From: [Andrew Clegg](#)
To: s 47F - privacy
Cc: [Marcus Grzechnik](#)
Subject: FW: ARPANSA Storage Facility Ventilation-Yallambie - ARPANSA Comments [SEC=UNCLASSIFIED]
Date: Friday, 25 May 2018 2:13:08 PM
Attachments: [SKM-1.pdf](#)
[Waste Store Ventilation Design ARPANSA Comments 2018-05-25.pdf](#)

Please find the waste store ventilation comments from ARPANSA.

SHEET TITLE:
STORAGE FACILITY
VENTILATION
SERVICES

May 2018
Scale: NTS
Drawing No.
SKM-1

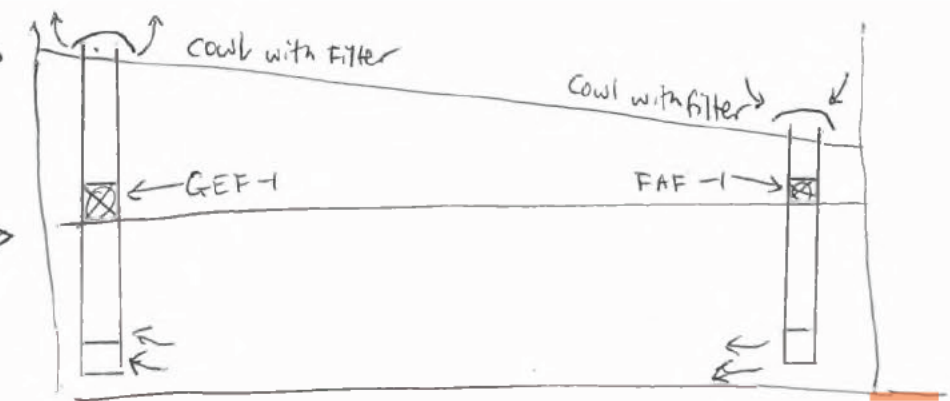
Internal Roof/Mezzanine mount OK for fan unit
External Roof mount for filter + cowl/vents.

Indication if
loss of ~~pressure~~
air flow to
be mounted at
postn 'A'
+ Filter.

Add Ladder Bracket at Postn 'B'
